## Dept Planning and Environment (now DPHI) analysis –Independent Rapid Assessment of the Parramatta CBD Planning Proposal for DPE (prepared by Bennett and Trimble) March 2022

**Dept Planning and Environment (now DPHI) analysis –Parramatta CBD Transition Area Review (Hassell) December 2022**

## Council Officer analysis of implications of SEPP 2 – June 2023

### Perspective View Looking West Along Parramatta River - Recommended

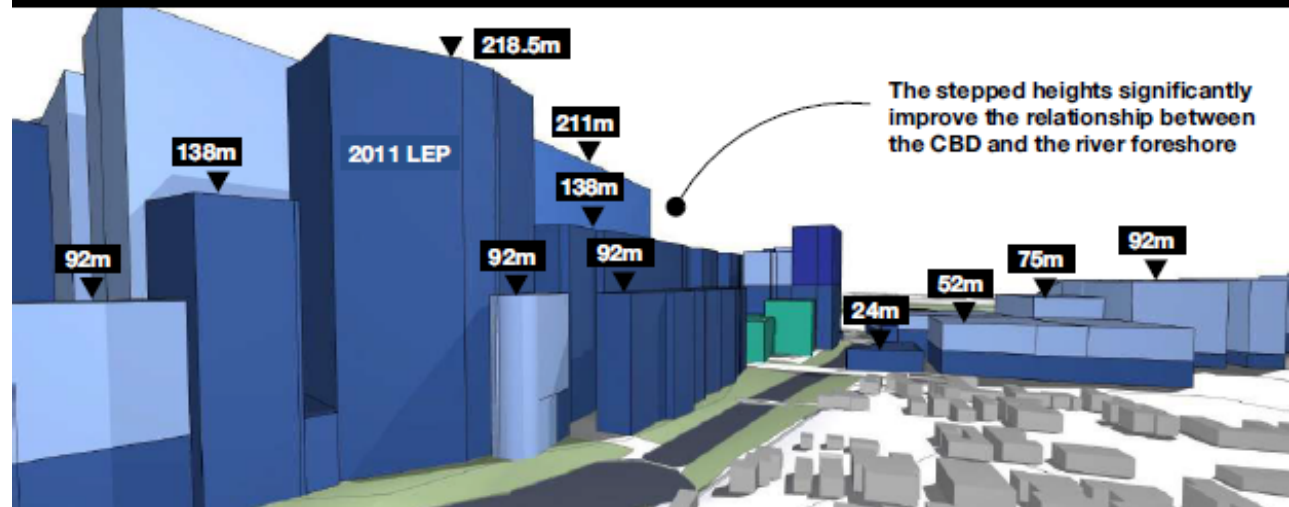
The proposed controls for height incentives, opportunity sites, and the solar access controls for Parramatta Square have loaded height on the southern edge of the Parramatta River foreshore. The resulting massing controls could result in urban form that overwhelms the river that is so central to its landscape and history. It would impact Parramatta's identity, and its desirability as a place to live and work. The relationships between the recently completed tall buildings and the river is unconvincing. They appear to commercialise the foreshore and visually dominate the river corridor. This type of development is similar to Southbank in Melbourne or Barangaroo in Sydney and may not offer the most sensitive or place-specific response that Parramatta deserves. The relationship between the Sydney CBD and its harbour, and Parramatta and its river, are substantially different in scale, aspect and siting, and yet the proposed controls encourage the same building

typologies, heights and relationship to the water's edge. The scale of development these controls permit risks overwhelming the scale of this important natural, historical and cultural asset.

As the metropolitan centre of the Central River City, the relationship between the river and the CBD will be critical to its future cultural identity and its desirability as a place to live and work. Recommendation: Reduce the proposed height incentives for buildings along the Parramatta River foreshore to protect the natural, historic and cultural qualities that are so central to the identity of Parramatta and its place within the Central River City. The permissible building envelopes should be commensurate with the scale of the river rather than a harbour.

**Recommended Height Controls**

FSR 9.7\*

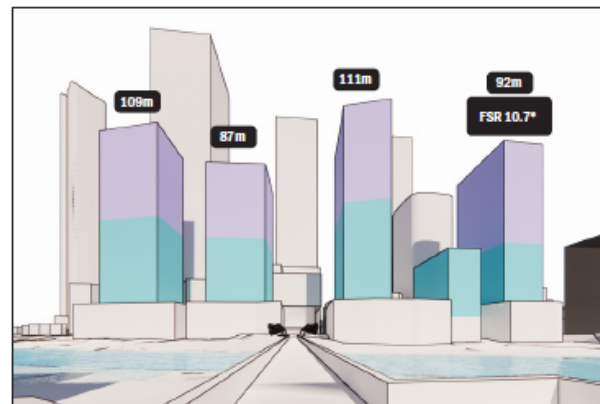
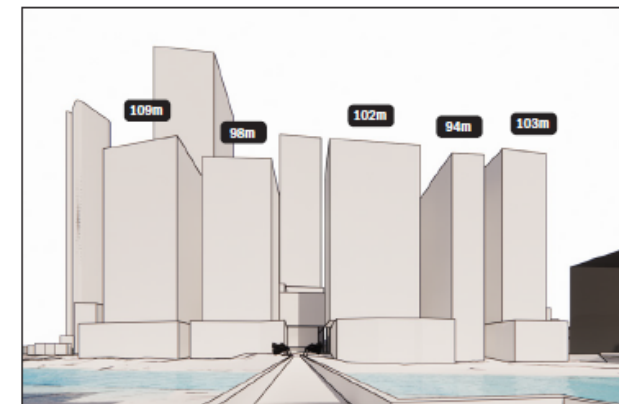
The total recommended maximum FSR is 9:7:1 including all bonuses but is only considered acceptable subject to conditions. This translates to bonus FSR on subject site of 2.5:1. Conditions for subject site include a maximum tower length when viewed from river of 35 metres.

Undesirable outcome (FSR 12.1 and current floorplate controls)

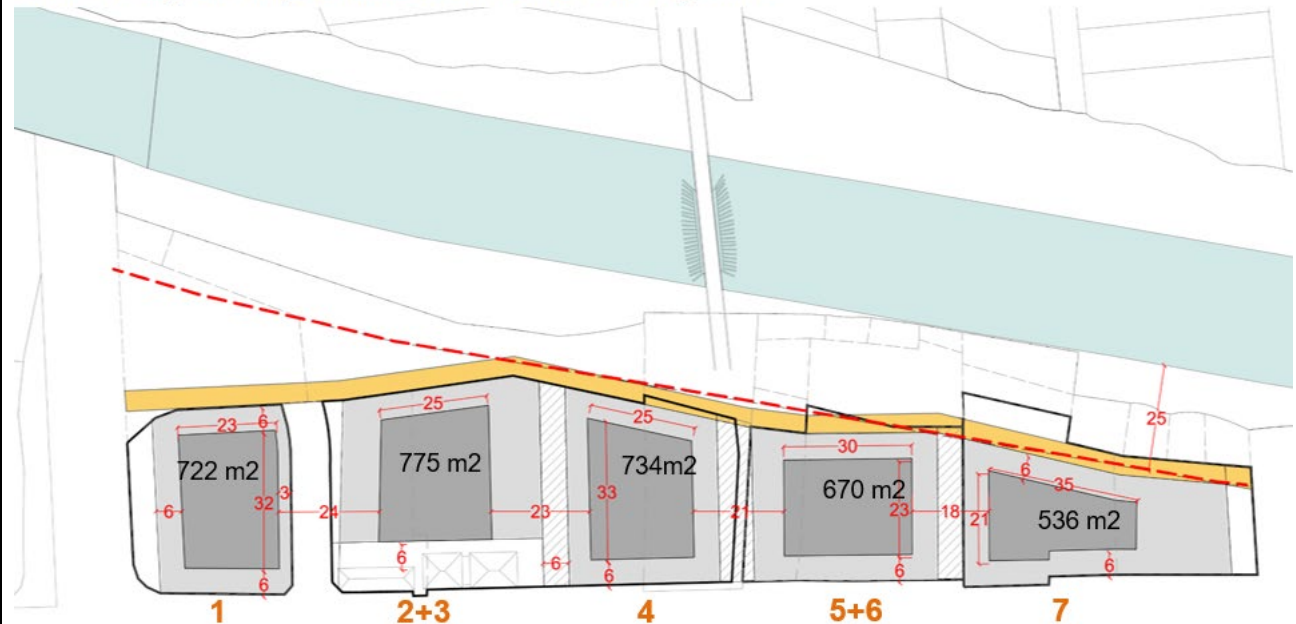
SEPP 2 inconsistent with PDCP 2023 which provides for maximum tower width of 45m.

**Challenges from current controls:**

- No incentive for the site to deliver the upper level promenade.
- Site can achieve HOB of 105m, however cannot achieve FSR of 9.7:1. Can only achieve FSR of 7:1 (Mixed Use) under 105m height control due to limitations of tower width.
